N4902B-01A-S

SERVICE NOTE

N4902B - Serial BERT 7 Gb/s

There is an unlikely possibility of an instrument catching fire due to a short-circuit

Graphics Card

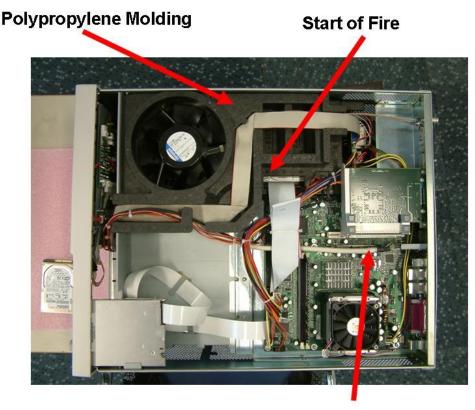
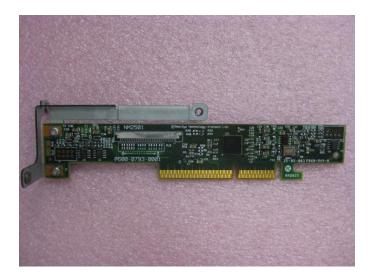
A surface-mount ceramic capacitor suffered physical stress during the manufacturing process, leading the capacitor to crack. During operation this crack placed stress on the internal structure of the capacitor, and caused the plates to short together. (The plates are separated by very little space, made up of very thin insulators.) This caused the capacitor to have very low residual impedance, resulting in a very high current conducted through the capacitor and the 12V path on the motherboard for some period of time. The low impedance didn't lead to a current high enough for blowing the fuse. Therefore the higher current was available long enough to create a very high temperature ($T > 300^{\circ}C$) The high temperature ignited the polyurethane molding used to conduct the airflow for cooling through the instrument.

The following photo illustrates the layout of the instrument. If shows the polypropylene molding, the graphics card and the starting point of the fire.

The countermeasure for this issue is to exchange the graphics cards. The new graphics cards are produced with an improved manufacturing process eliminating the risk of micro cracks. They either have an additional fusing to protect the 12V path or they have eliminated the 12V path altogether. The graphics card can be exchanged by Agilent authorized personnel only.

Motherboard still considered being good – no exchange required:

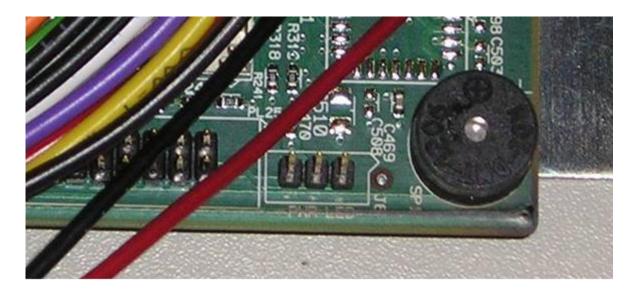
There might be discoloring on the PC motherboard in the shown corner (brown color). This can be ignored. The function or the quality of the motherboard is not affected by this.

Motherboard considered being bad – please exchange:

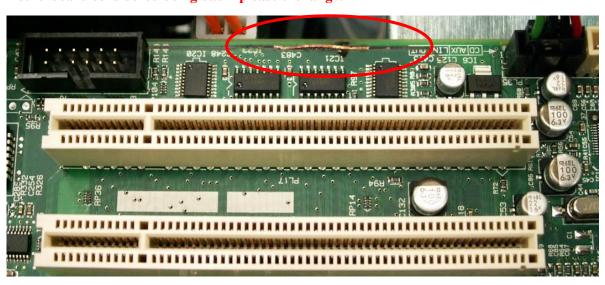
In very exceptional cases if you see traces of smoke or fire, the motherboard needs to be exchanged. In these cases typically the integrated display of the instrument would not work anymore. The exchange of the motherboards can only be done in the Service Center - onsite repair is not possible.

The following discoloring is intentional – no exchange required:

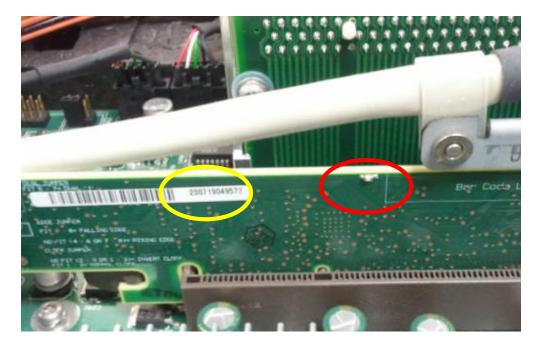
This effect is caused by an intentional sealing of a high impedance area to avoid issues in environments with a high degree of humidity. No exchange of the motherboard is required here.

o Sample #1 (Revision NM2501):

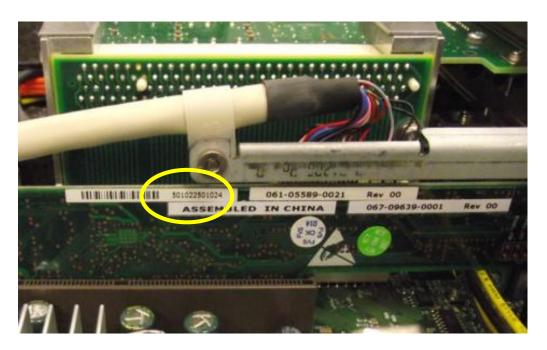
The board has a fuse on top (red circle) and a serial number (yellow circle) starting with 200... In the case above it is 200719049572)

o Sample #2 (Revision NM2502):

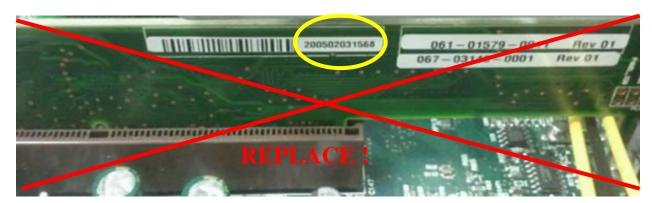
The board has a serial number (yellow circle) ${\bf NOT}$ starting with 200... In the case above it is: 501022501024.

shows a serial number starting with 200... AND no fuse is visible

it is potentially **hazardous** and the **unit must be set out of operation** until the graphic board is replaced (part number: N4901-66577 or N4901-69577). The graphic board can be exchanged without impacting the instrument's performance.
